SERVICE BULLETIN

Bulletin N° 004/July/09

All ISP manufactured products including Lifejackets and Bladder Assemblies fitted with **HALKEY ROBERTS ALPHA 9000 OPERATING HEADS**

Notification of Safety Information issued by the Manufacturer of **HALKEY ROBERTS ALPHA 9000 OPERATING HEADS**

Illustration 1

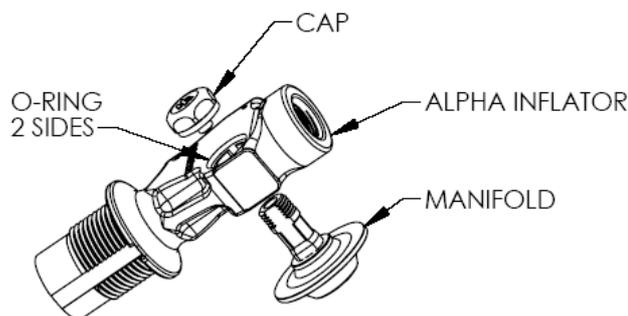
When fitting (or re-fitting) a CO₂ cylinder to a Halkey Roberts Alpha 9000 operating mechanism (Illustration 1) on an ISP manufactured product and the cylinder sealing gasket or 'O' ring is damaged and needs replacing, the replacement seal that should be used is the 'tabbed gasket washer' (Illustration 2). The 'tabbed gasket washer' is to be used in place of the black 'O' ring cylinder seal and the white 'O' ring cylinder seal that were fitted to earlier versions of the Alpha 9000 operating mechanism.

The ISP Part Number for the 'tabbed gasket washer' is 90-ISP-9IX-014
